REGIONAL REVIEW FINDING

ARC REVIEW CODE: R15052701

Name of Proposal: Pinewood Atlanta Studios

SUBJECT: **Transportation Division Review of DRI # 2480**

DRI SITE PLAN

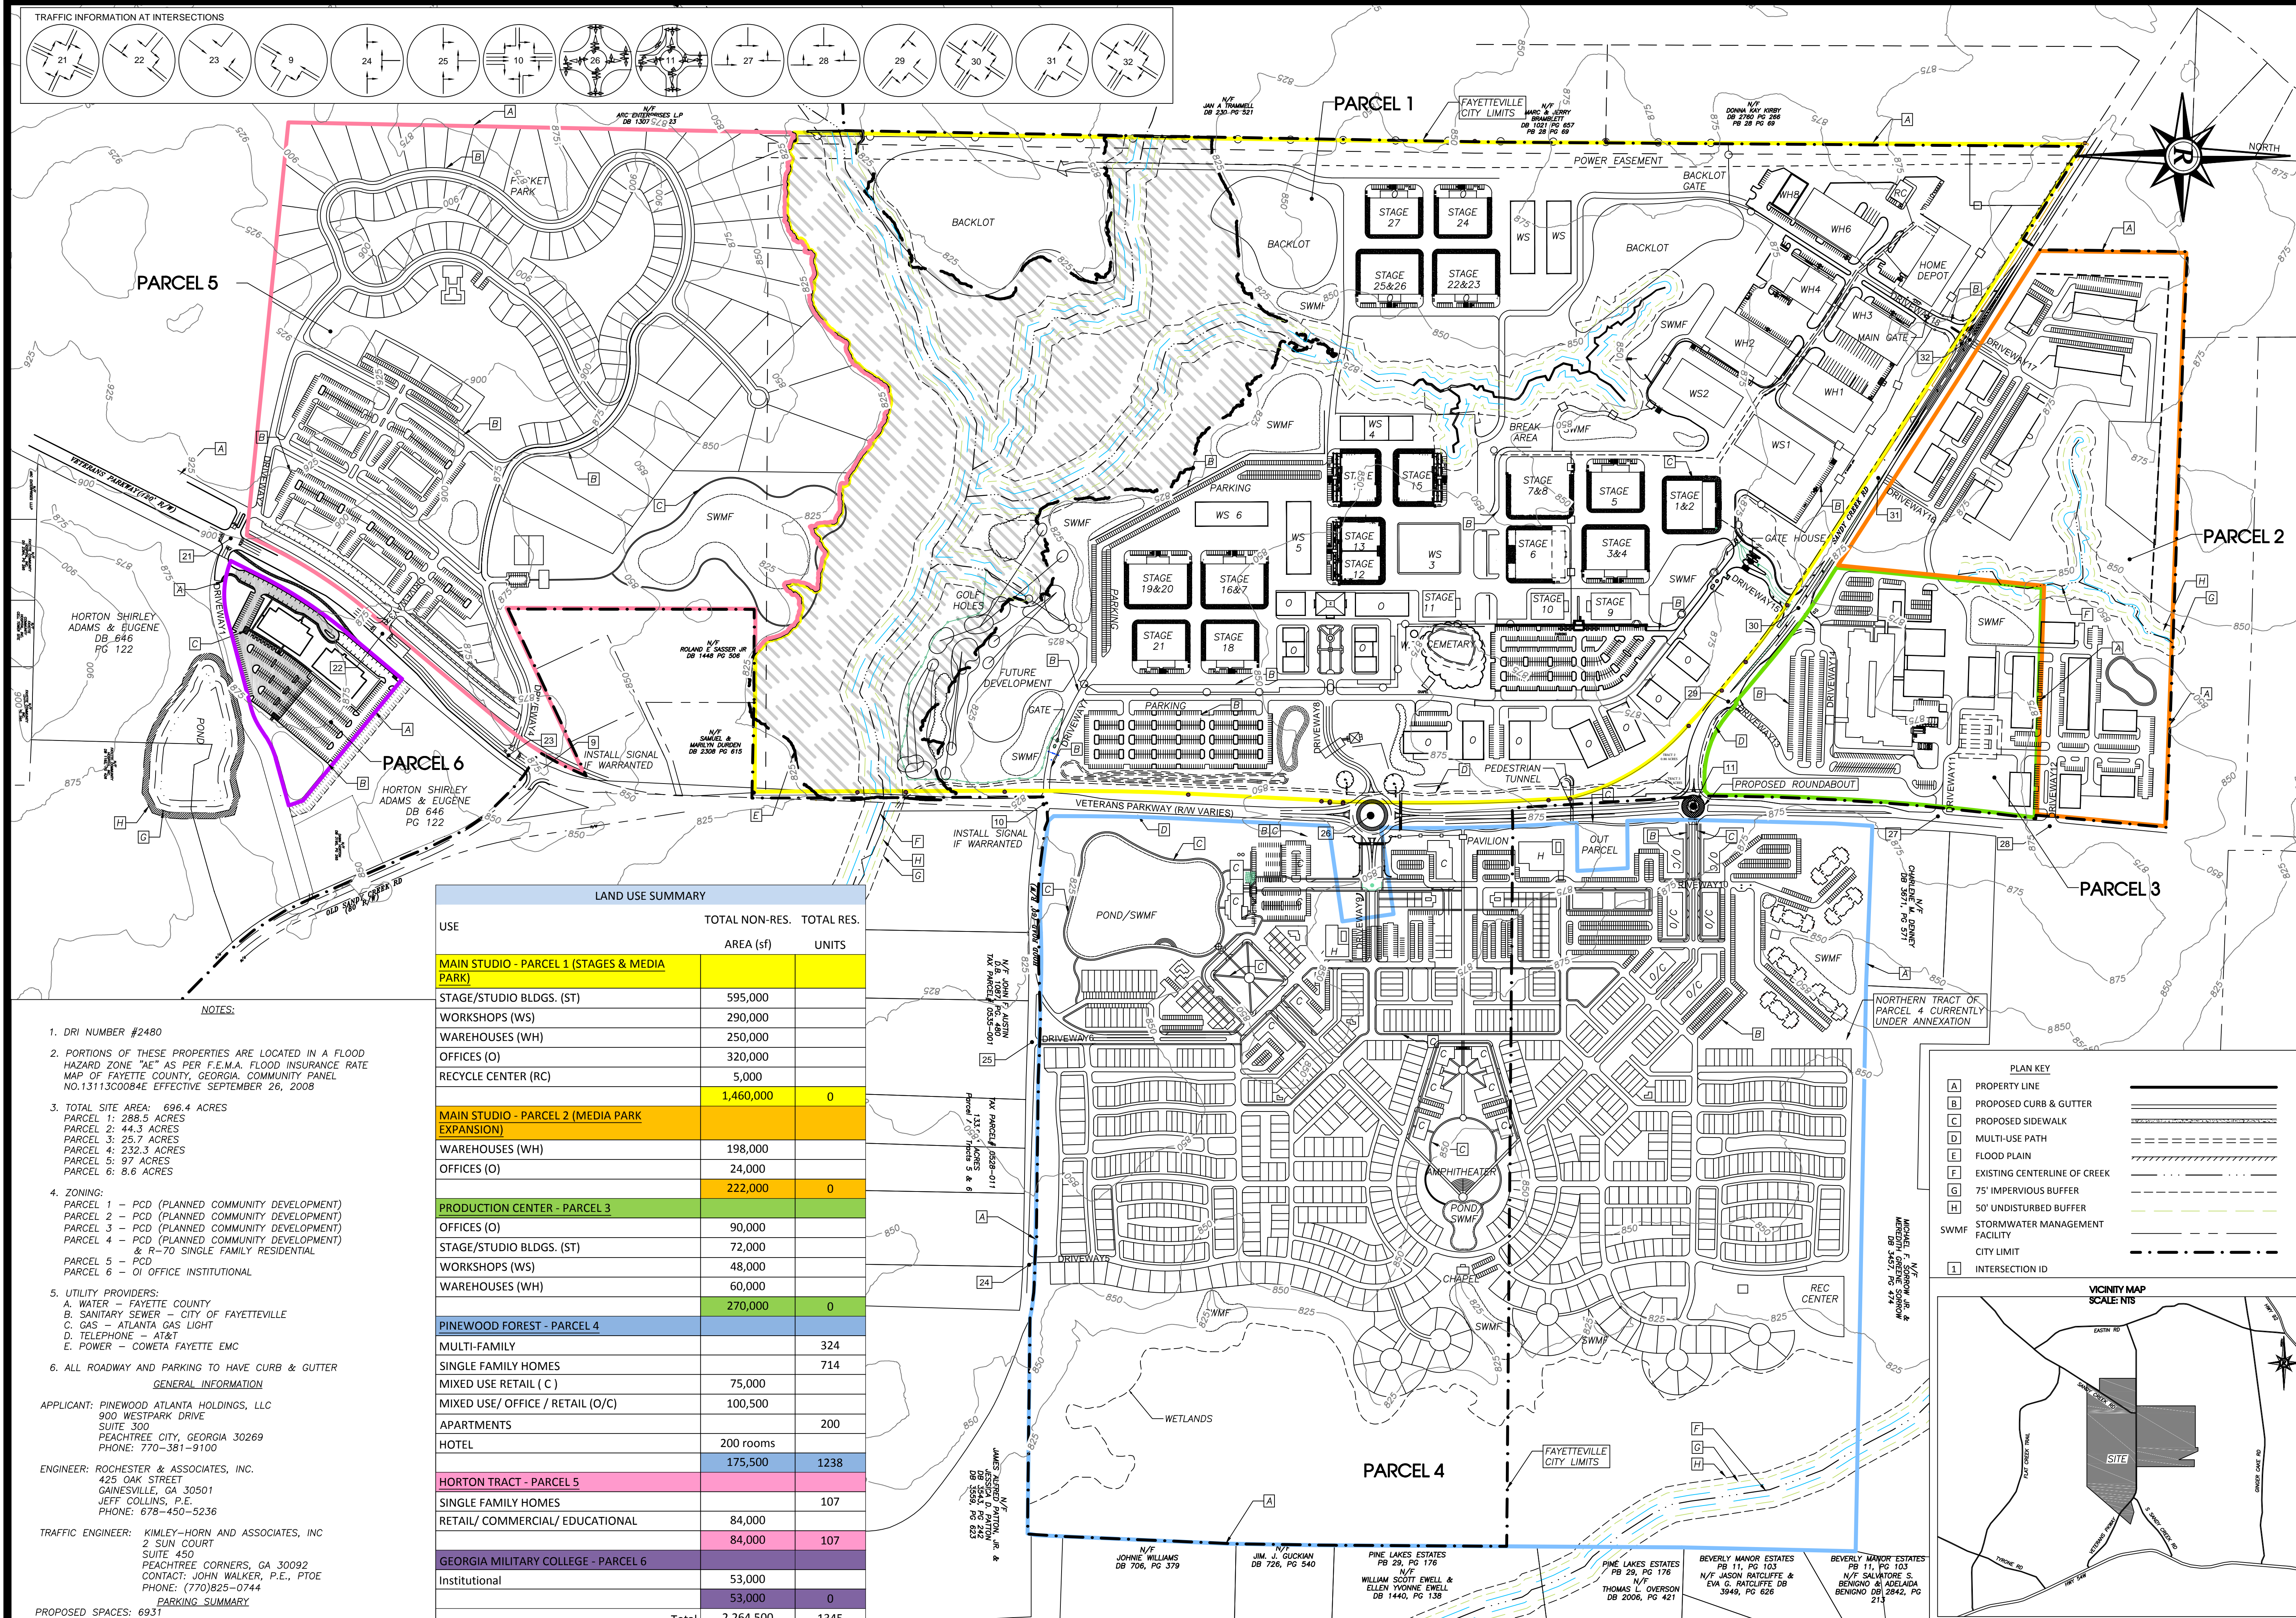
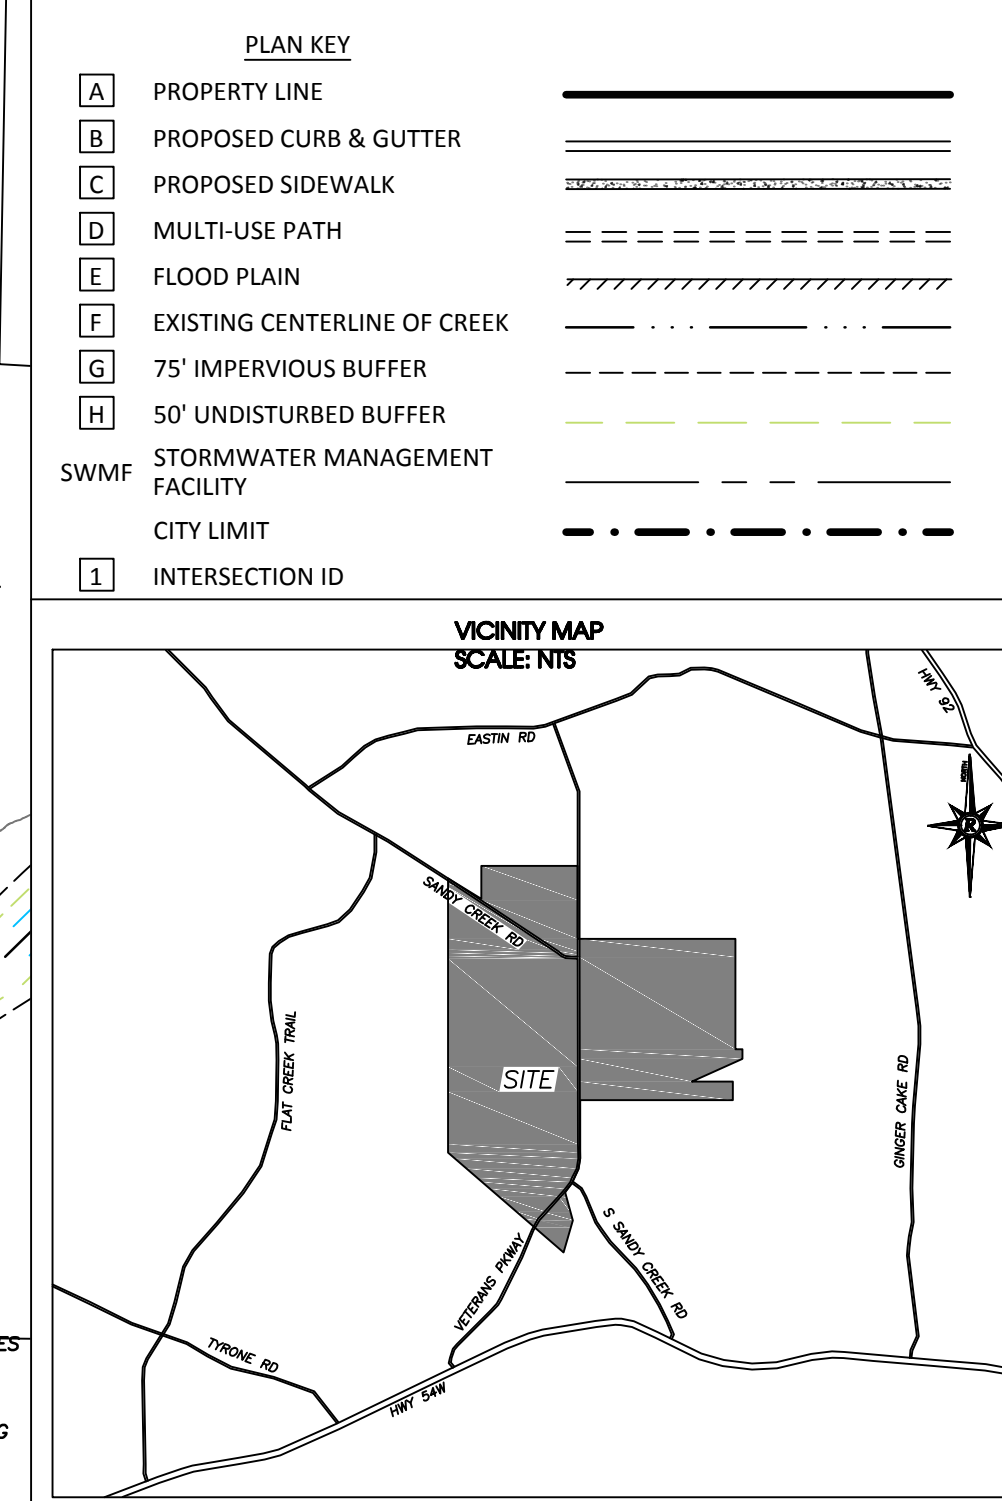
The submitted site plans show a 50-foot undisturbed buffer and 75-foot impervious setback on all streams shown on plans. The USGS coverage for the project area shows Sandy Creek and two unnamed tributaries on the property as perennial streams. The City will need to determine if the proposed project meets all the applicable requirements of its water supply watershed protection ordinance.

All identified streams on the property will be subject to the City's Stream Buffer Ordinance, which requires a 50-foot undisturbed buffer and a 75-foot impervious surface setback. These buffers are shown along all the streams included on the proposed project plans. All these streams as well as any other waters of the state on this property are also be subject to the State 25-foot Sediment and Erosion Control Buffer.
